Access Compliance Report Public Rights-of-Way (Pedestrian Signals)

Main Street: **N_MEADS_AVE** Cross Street: **N_MEADS_AVE** Location: **SE**

ADA ID: **SGRK211222124109** Signal Type: **One Push Button-Non APS** Overall Compliance: **No** Severity Scores: **BTN 1: 30** **BTN 2: N/A** **No BTN: N/A**

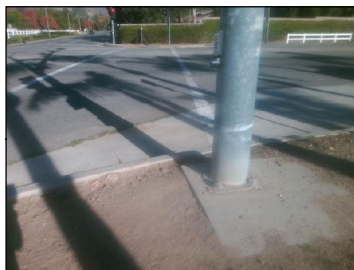
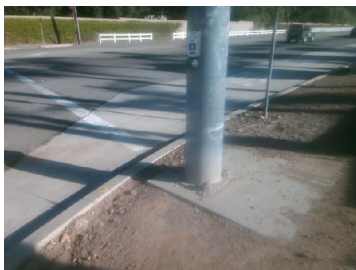
OC Std/PROW: **R404.3, R406, MUTCD 4e.08, DMS-11132, R104.2, R209.1**

Possible Solutions: Replace Signal Push Button With APS Button. Provide PAR As Indicated.
